EPSON PRODUCT SUPPORT BULLETIN

Date:	04/20/2009	Originator:	JAM
PSB #:	PSB.2009.06.001	Authorization:	<i>Kas</i>
Reference:	TI 09-05e Rev. A/B	Total Pages:	5
Product(s):	PowerLite 735c / Cinema 500 / 737c / 745c / 755c / 765c / 830p / 835p / 1705c / 1715c / 6100i / 6110i / 7800p / 7850p / 7900NL / 8300i / 8300i with EasyMP.net module / 9300NL / 1815p / 1825 / 822p / 83c / 822+ / 83+ / G5000 / Pro G5150 / Pro G5350 / Pro G5200W / 1725 / 1735W / 400W / 410W / 84 / 85 / 825 / 826W PowerLite 61p / 81p / 82c / 821p / 1810 / 260d (Latin America) / 280d (Latin America) with TCP/IP to Serial converter		
Subject:	Release of EMP Monitor for Windows version 4.30

EMP Monitor V4.22

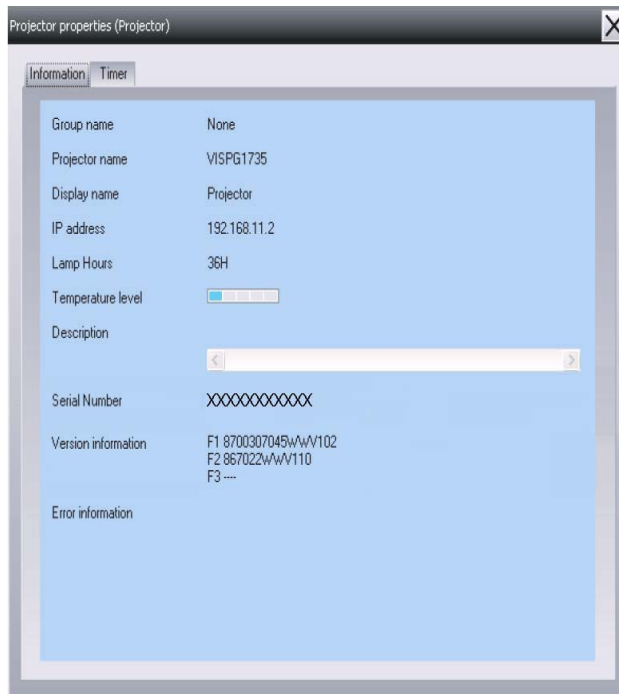
(2) Addition of Input Source (Only PowerLite 84 / 85 / 825 / 826W)
Previous version of EMP Monitor included USB Display, USB and LAN as one source: EasyMP.

The input source buttons for USB display, USB, and LAN are available as separate input sources as shown below:
